PJM Interconnection, L.L.C.  
2750 Monroe Boulevard  
Audubon, PA 19403

May 16, 2025

*Re: PJM Interconnection, L.L.C., Docket No. ER25-2244-000  
Amendment to ISA, Service Agreement No. 6904; Queue No. AC2-157*

## SINGLE-LINE DIAGRAM

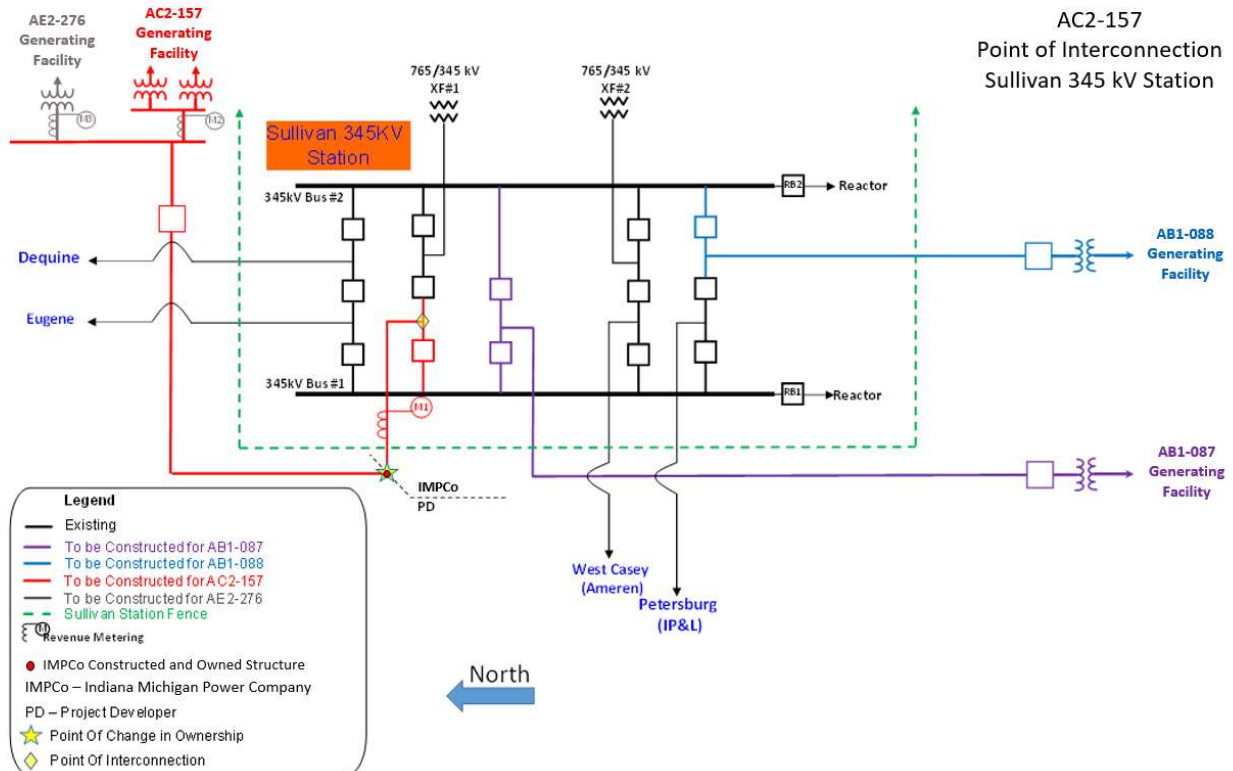
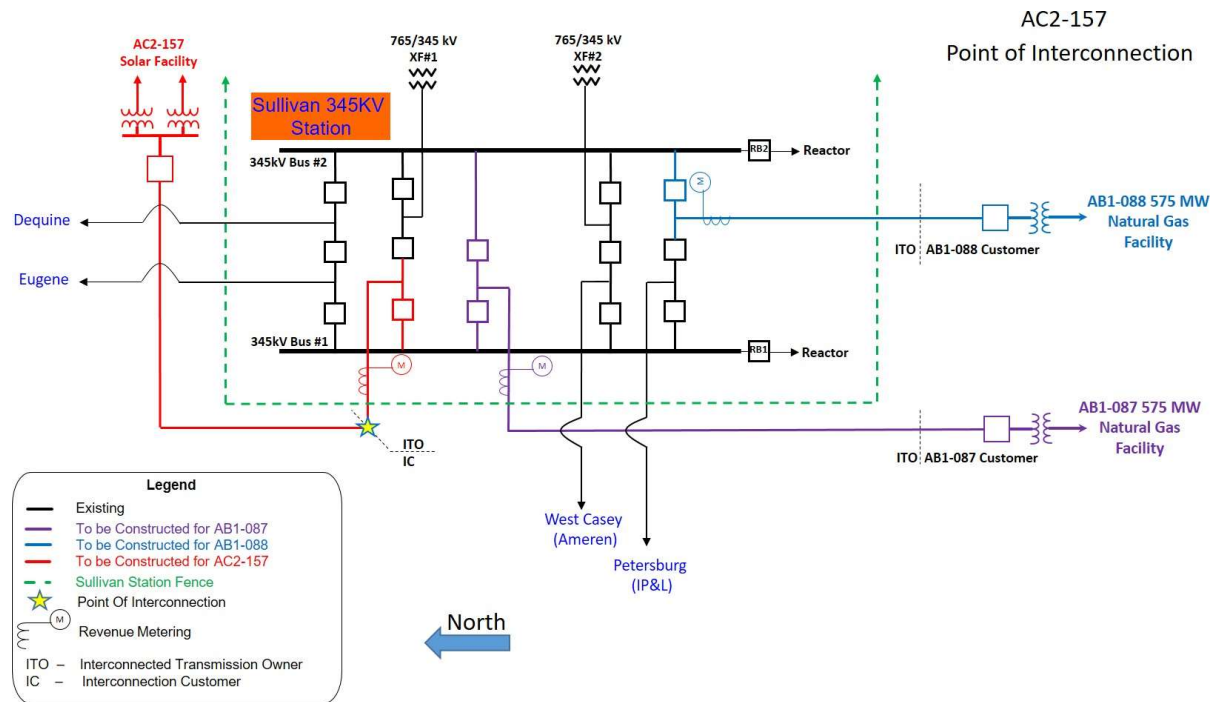
Third, Schedule B (Single-Line Diagram) now includes a depiction of the AE2-276 generating facility at the radial end of the Interconnection Facilities. Further, Schedule B contains

an updated description of the point of change in ownership on the Interconnection Facilities, and the Point of Interconnection on the Transmission System.

~~The Point of Interconnection (“POI”) is the first structure in the generation lead circuit outside of AEP's Sullivan 345kV switching station fence. AEP will own the span from the Sullivan 345kV switching station to the first structure, and AEP will own the structure, including the jumpers. Interconnection Customer will own the other span connecting to that structure, comprising the 345kV generator lead transmission line and associated structures back to the AC2-157 generation collector substation.~~

The Point of Interconnection (“POI”) for AC2-157 and AE2-276 is the point where the risers connect the generation lead circuit to the Sullivan 345 kV Station line termination point. The Point of Change in Ownership (“PCO”) will be located at the first structure in the generation lead circuit outside of the Sullivan 345 kV Station fence. IMPCo will own the span from the Sullivan 345 kV Station to the IMPCo-constructed and owned dead-end PCO structure, including the jumpers. Interconnection Customer will own the other span connecting to the PCO structure, along with the remainder of the 345 kV generation lead circuit and associated structures to the generation collector substation.

### SINGLE-LINE DIAGRAM

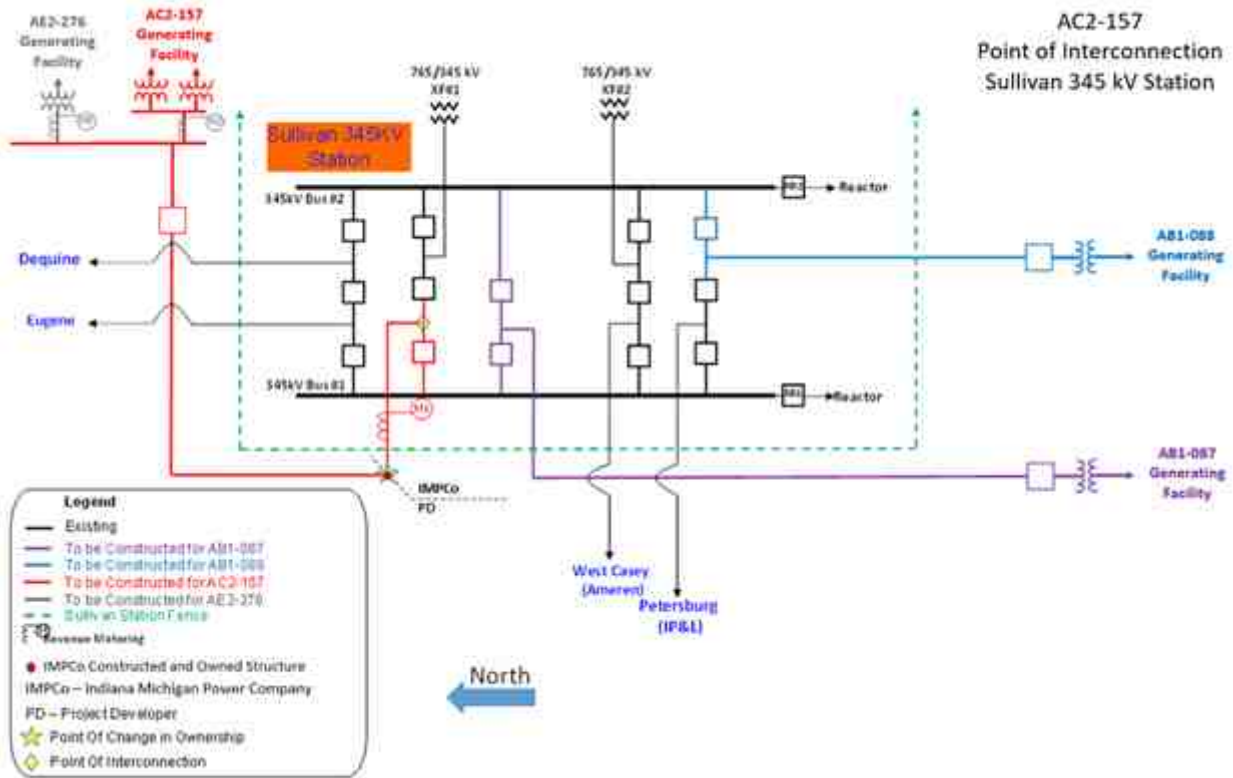
The Point of Interconnection (“POI”) for AC2-157 and AE2-276 is the point where the risers connect the generation lead circuit to the Sullivan 345 kV Station line termination point. The Point of Change in Ownership (“PCO”) will be located at the first structure in the generation lead circuit outside of the Sullivan 345 kV Station fence. IMPCo will own the span from the Sullivan 345 kV Station to the IMPCo-constructed and owned dead-end PCO structure, including the jumpers. Interconnection Customer will own the other span connecting to the PCO structure, along with the remainder of the 345 kV generation lead circuit and associated structures to the generation collector substation.
